### PIP5811 Crankshaft Balancer Contacting Timing Cover on Replacement Engine

Involved Region or Country	North America
Condition	Crankshaft Balancer Pulley Contacting Timing Cover After Installation on Replacement Engine Part Numbers 19368174 and 19368176
Cause	Incorrect Crankshaft Timing Gear Installed

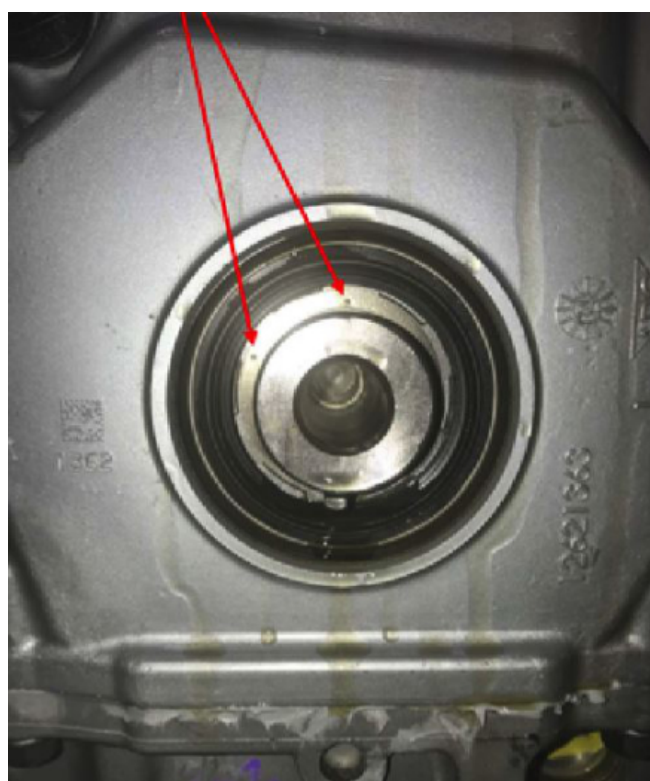
To identify if the engine was assembled with the incorrect crankshaft timing gear inspect for 5 dimples on the crankshaft timing gear (the incorrect gear will NOT have these dimples present), the dimples should be visible with the cover installed and balancer removed (see below):

Further confirmation can be made with the timing cover of and measuring from the end of the crankshaft to the end of the gear (see below), this measurement should be approximately 1 1/16" (27.0mm).

If it has been confirmed that the lower crankshaft timing gear is incorrect, crankshaft timing gear P/N 12631214 along with a new oil pump will need to be installed.
